METROPOLITAN GOVERNMENT OF NASHVILLE AND DAVIDSON COUNTY

STAFF RECOMMENDATION 1708 Cedar Lane February 20, 2013

Application: New Construction – Outbuilding
District: Belmont-Hillsboro Neighborhood Conservation Zoning Overlay
Council District: 18
Map and Parcel Number: 11704024100
Applicant: Kaitlyn Smous, Allard Ward Architects
Project Lead: Michelle Taylor, michelle.taylor3@nashville.gov

1 Site Plan

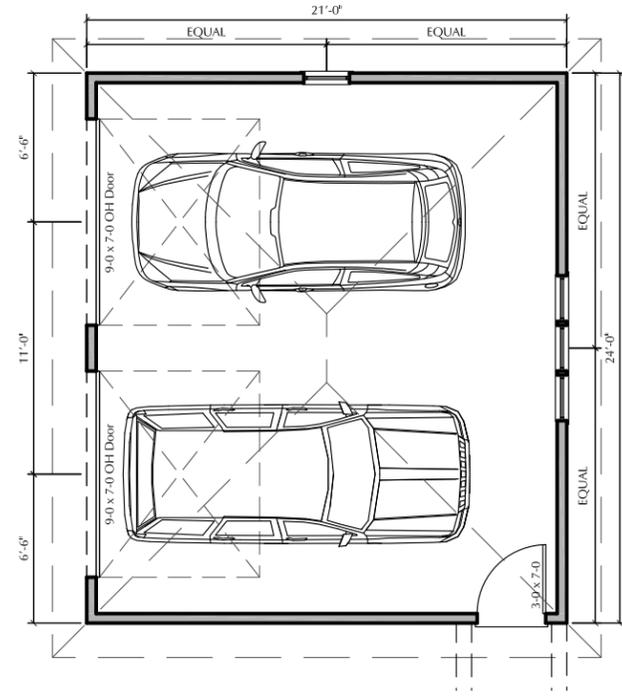
Location and Setback: The proposed outbuilding is located towards the rear of the property, as seen historically in this neighborhood. The proposed location for the outbuilding meets the required five foot (5') rear setback and well exceeds the required three foot (3') side setback on the right. However, for structures of this size with street loading, Codes requires a street setback of twenty feet (20').

As proposed, the outbuilding would be setback three feet, two inches (3'2") on the left, which is the street loading side. Staff finds the reduction of the side setback appropriate for several reasons. First, the locations of historic outbuildings were of minimal distance from alleys and streets and additionally, there is a ten foot (10') wide public right-of-way between the property line and Brightwood Avenue, which helps to reduce the perceived lack of a setback. For these reasons, staff finds that the proposed location of the outbuilding is appropriate.

The proposed driveway is approximately twenty-nine feet (29') wide and generally the Commission has requested that driveways, where they are appropriate should be a single lane. Staff recommends a driveway that is no more than twelve feet (12') at the curb and blooms out to two-lanes deeper into the property. This may require that the building be setback further than what is proposed.

With the condition the driveway is no more than twelve feet (12') at the curb, the project meets section II.B.c of the design guidelines.

Drawings:
 Garage Floor Plan
 and Elevations
 Date:
 01.29.13

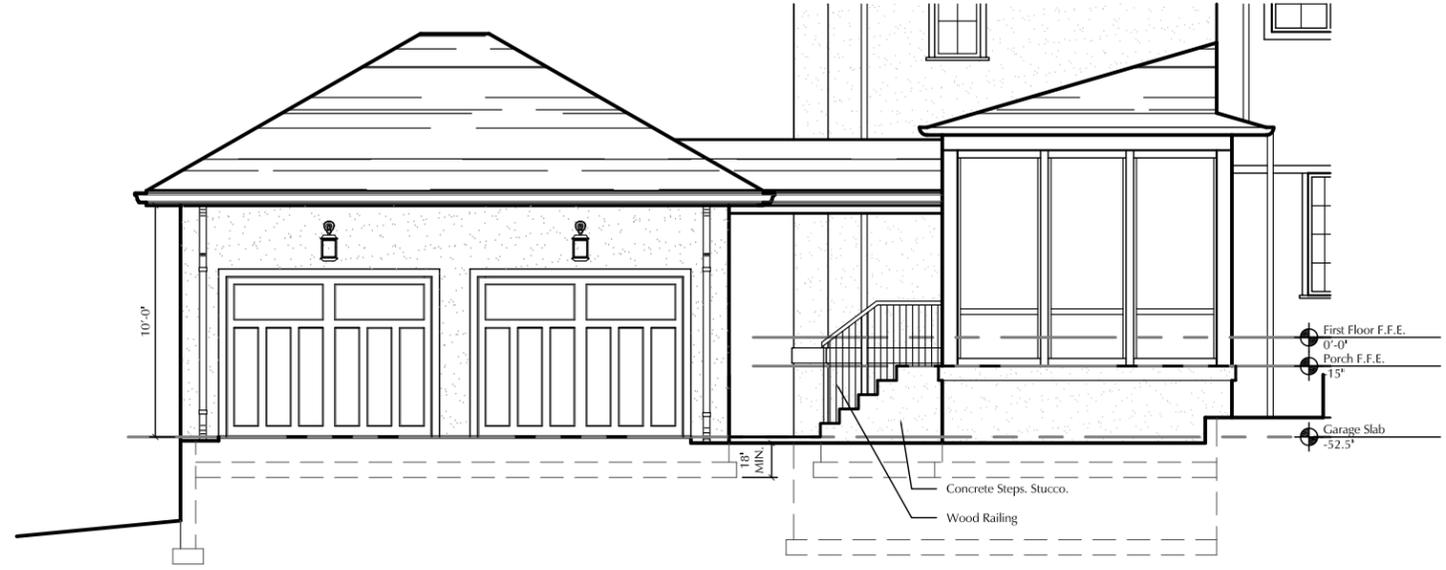
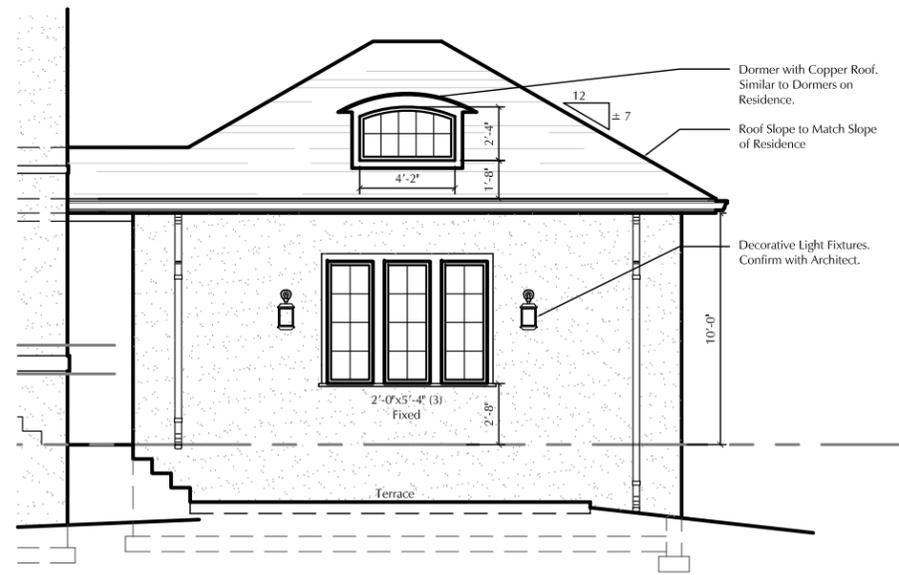
Height & Scale: The massing of the outbuilding is subordinate to the historic home. The garage is eighteen feet (18') tall from grade compared to the existing house which is approximately twenty-seven feet (27') tall from grade. The eave height is fourteen feet (14') to grade compared to the existing house which is twenty-three feet (23') to grade. The footprint of the outbuilding is approximately five hundred and four square feet (504 sq ft) compared to the existing house which has a footprint under two-thousand square feet (2000 sq ft), before the recent addition.

Roof Shape: The seven-twelve (7/12) pitch of the hipped roof is typical for the neighborhood and is compatible to that of the existing house. One dormer is planned but is not street-facing.

Proportion and Rhythm of Openings: The rhythm of openings matches the surrounding context and is typical of historic outbuildings.
